Date: 22 June 2000
 To: T10 Technical Committee
 From: Ralph O. Weber
 Subject: SAM-2 Byte Count That's Really Buffer Size

The working group agreed that SAM-2 should be changed to use the 'command byte count' concept shown in the figure, as opposed to the written definition. This proposal contains a collection of specific SAM-2 changes to meet the working group request.

Figure 29 — Model for buffered data transfers

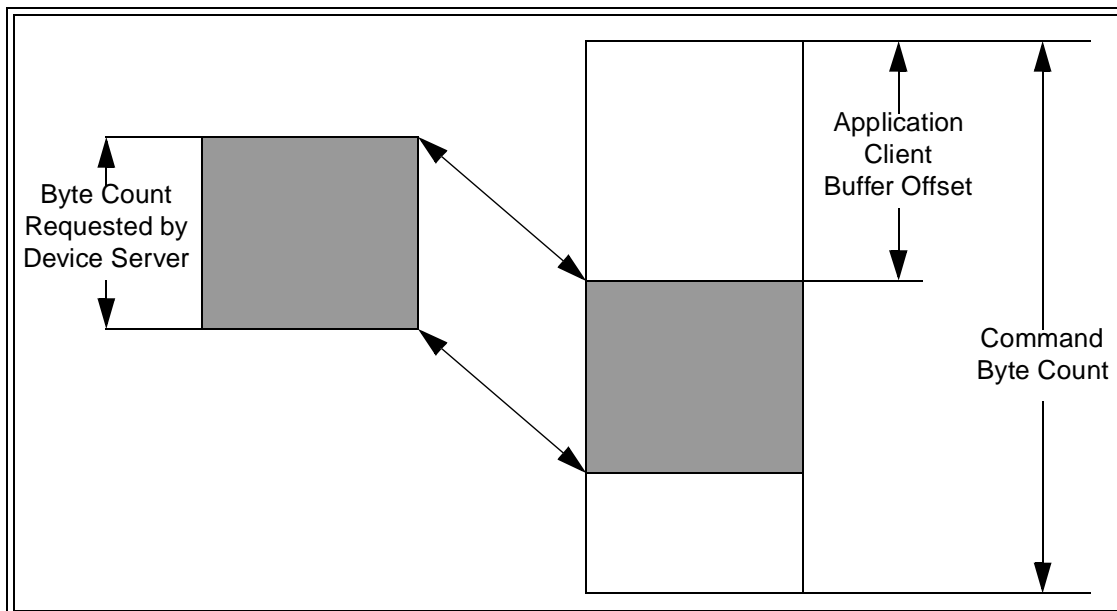
During the working group review of this issue, the following SAM-2 (and SAM) figure was discovered on SAM-2 rev 13 pdf page 70.

Clearly, this usage of 'command byte count' is the application client data buffer size and exactly the entity that FCP-2 wants to reference.

Change 4: In figure 29 (the figure reproduced above) after the second paragraph of 5.3.1 (SAM-2 rev 13 pdf page 70)

Replace 'Command Byte Count' with 'Application Client Buffer Size'
